Rezoning Transportation Analysis

Petition Number: 2023-011

General Location Identifier: 04521224, 04521223

Revision Log:

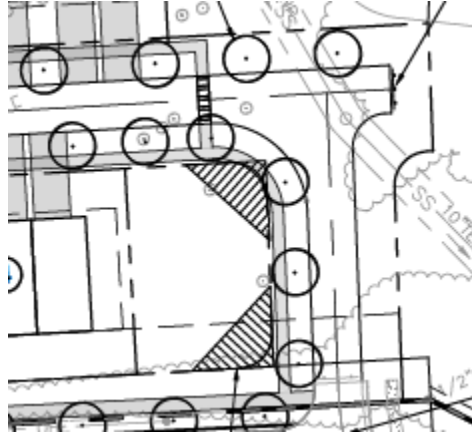
~~4. **Revise site plan and conditional note(s) to commit to construct an 8-foot planting strip, and 6-foot sidewalk on all internal roadways Chapter 19. The site plan shall label and dimension both items from the back of curb and gutter or edge of pavement.**~~

~~**Clarifying comment 6.21.2023:** Add conditional note to construct 8-foot planting strip and 6-foot sidewalk on all internal roadways.~~

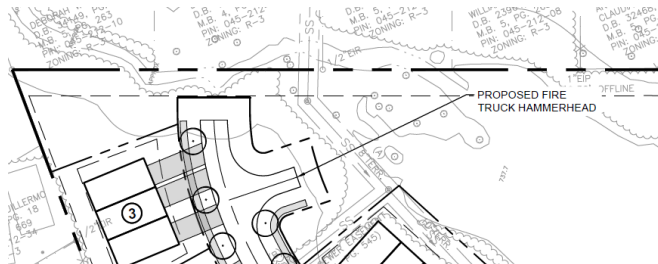
- ~~5. Add a conditional note specifying "A Right-of-Way Encroachment Agreement is required for the installation of any non-standard item(s) (irrigation systems, decorative concrete pavement, brick pavers, etc.) within a proposed/existing City-maintained street right-of-way by a private individual, group, business, or homeowner's/business association. An encroachment agreement must be approved by CDOT prior to construction/installation. Contact CDOT for additional information concerning cost, submittal, and liability insurance coverage requirements."~~
- ~~6. Revise site plan and conditional note(s) to commit to streetscape along both sides of all proposed roadways.~~
